## **CUTTS PLACE SUBDIVISION**

APPLICATION NUMBER 9 DATE May 18, 2017

REQUEST Subdivision

# DETAIL SITE PLAN

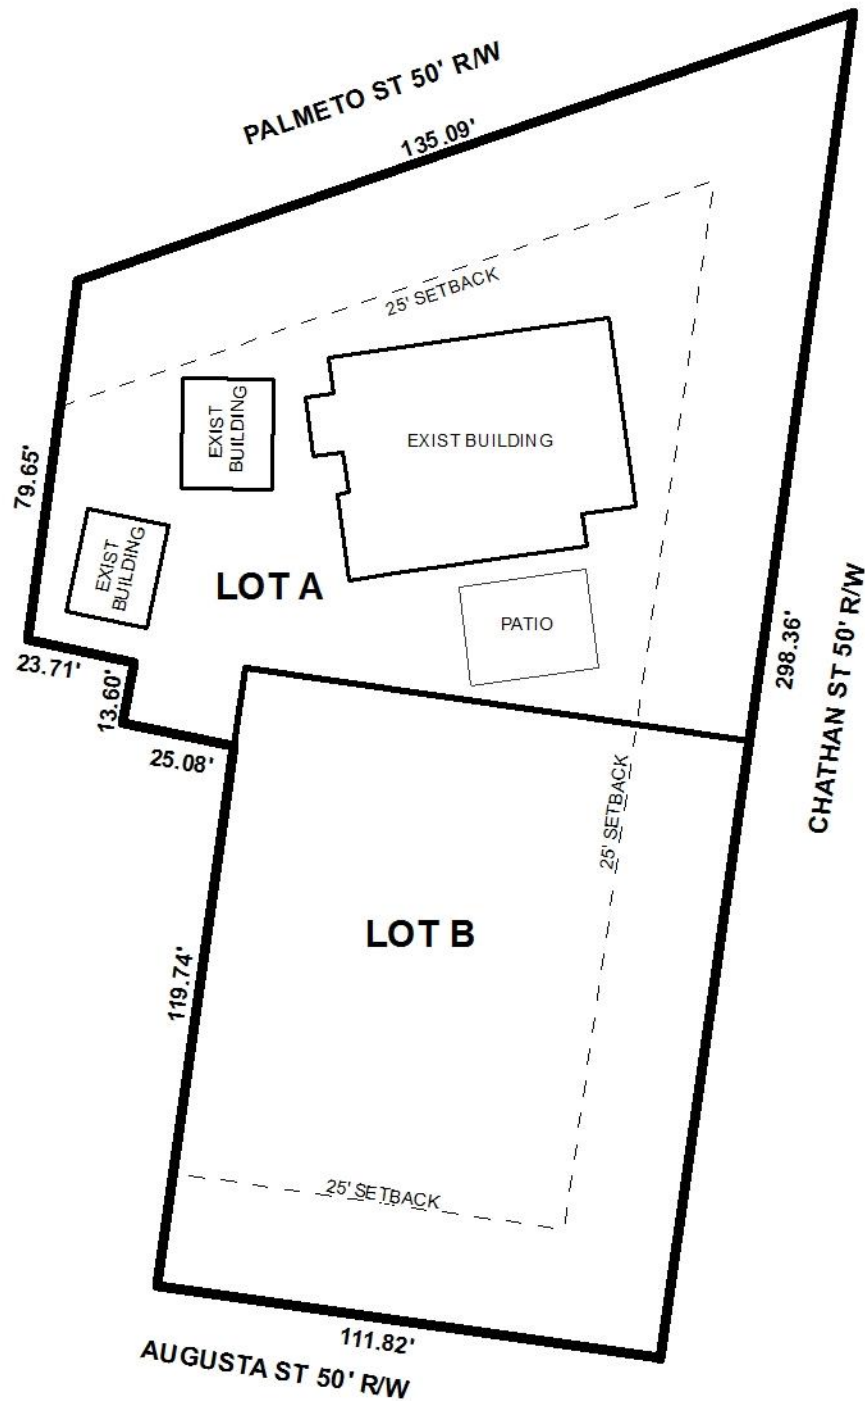
It should also be noted that the preliminary plat identifies the proposed lots as “Parcel A” and “Parcel B”; however, given the legal differences between parcels and lots and the inherent purpose of the subdivision application, the plat should be revised to correctly identify the proposed lots as “Lot A” and “Lot B,” or some other denomination thereof. For the purpose of the Staff Report, the proposed lots are herein referred to as “Lot A” and “Lot B.”

Dedication of the corner radii at the intersections of Palmetto Street and Chatham Street, and Chatham Street and Augusta Street, should be required per Section V.D.6. of the Subdivision Regulations.

With regards to access management, neither proposed lot currently has access to Chatham Street; instead, proposed Lot A has one existing curb cut to Palmetto Street and proposed Lot B has one existing curb cut to Augusta Street. As such, a note should be required on the Final Plat stating each lot is limited to its existing curb cut, with any changes in its size, design, or location to be approved by Traffic Engineering and conform to AASHTO standards.

It should be noted that Palmetto Street is incorrectly labeled as “Palmeto Street” on the preliminary plat; therefore, the plat should be revised to correctly label Palmetto Street, if approved.

- 1) revision of the plat to correctly identify the proposed lots as “Lot A” and “Lot B”;
- 2) dedication of the corner radii at the intersections of Palmetto Street and Chatham Street, and Chatham Street and Augusta Street per Section V.D.6. of the Subdivision Regulations;

- 3) placement of a note on the Final Plat stating each lot is limited to its existing curb cut, with any changes in its size, location, or design to be approved by Traffic Engineering and conform to AASHTO standards;

- 4) revision of the plat to correctly identify “Palmetto Street”;
- 5) retention of the lot sizes in square feet and acres on the Final Plat;
- 6) retention of the 25’ minimum building setback line along all street frontages;
